# UNITED STATES PATENT AND TRADEMARK OFFICE

APPLICATION NO.	FILING DATE	FIRST NAMED INVENTOR	ATTORNEY DOCKET NO.	CONFIRMATION NO.
10/808,557	03/25/2004	Makoto Iwashima	61355-054	4774

**Office Action Summary**

Over charging and over discharging signals are transmitted to the BCU via a single signal wire

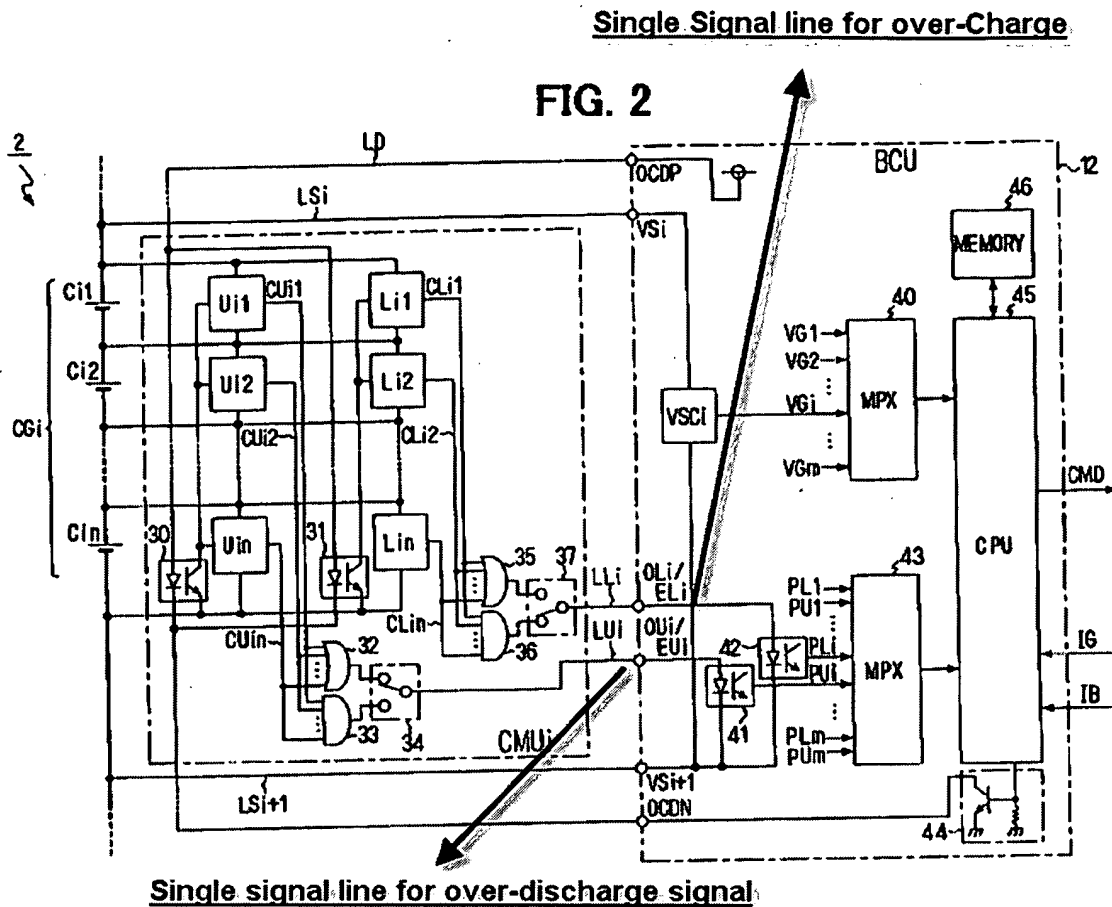
Applicant argues that there is no teaching in Tamura et. al. a signal input from each of the malfunction detection devices through a single line. This is incorrect. Tamura et. al. disclose a single line for over-charging and a single line for over-discharging signals from the detection devices to the controller (see figure below).
